**APPLICATION FOR A CERTIFICATE OF APPROPRIATENESS FOR
A SIGN IN A SPECIAL PROVISION SIGN DISTRICT (SPSD)**

CASE NUMBER: 2208220001

LOCATION: 2550 Pacific Avenue
(northeast elevation)

REQUEST: An application for a Certificate of Appropriateness by Bobby Nichols of Chandler Signs, Inc., for a 245-square-foot illuminated attached sign at 2550 Pacific Avenue (northeast elevation).

NORTHEAST CORNER - PROPOSED SIGNS

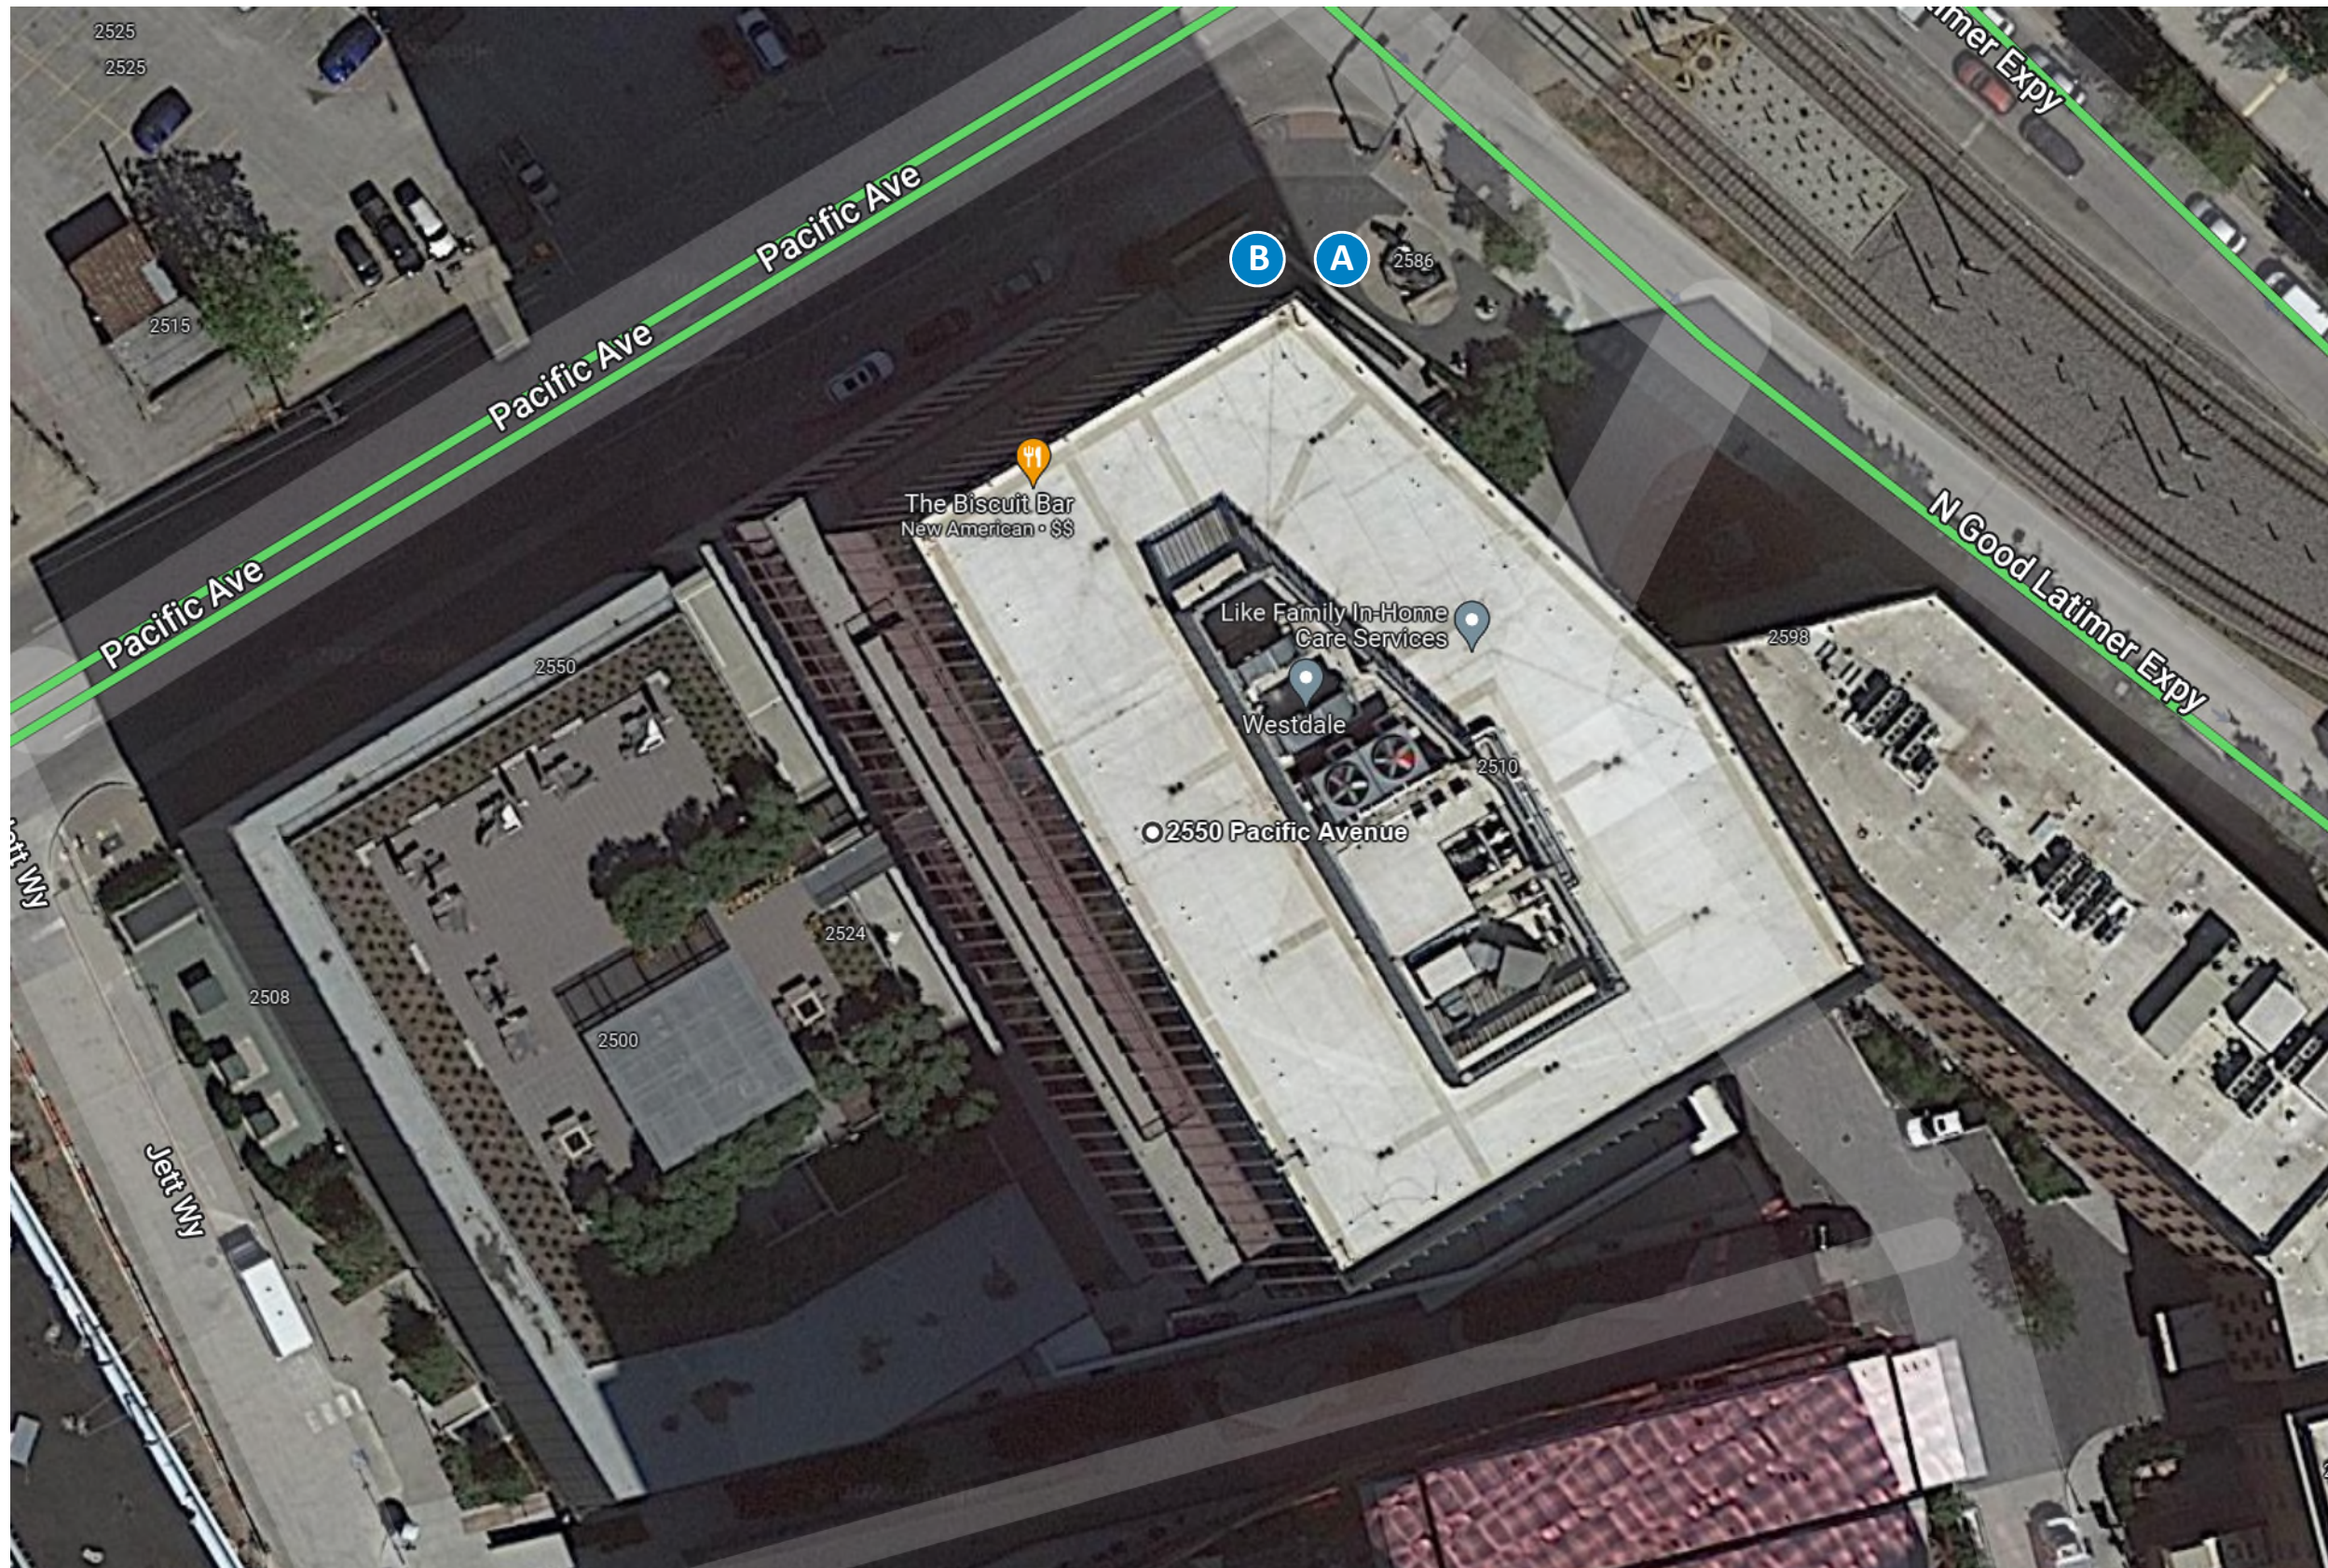
The total area of the northeast façade is approximately 52,500-square-feet. Sign A occupies less than 1% of the façade. The existing Biscuit Bar sign, approved under CA 1909120018 in November 2019, is approximately 69-square-feet and is currently the only sign on this facade. The word count on the proposed Sign A does not exceed eight words over four-inches in

STAFF RECOMMENDATION: Approval

SSDAC RECOMMENDATION: Approval
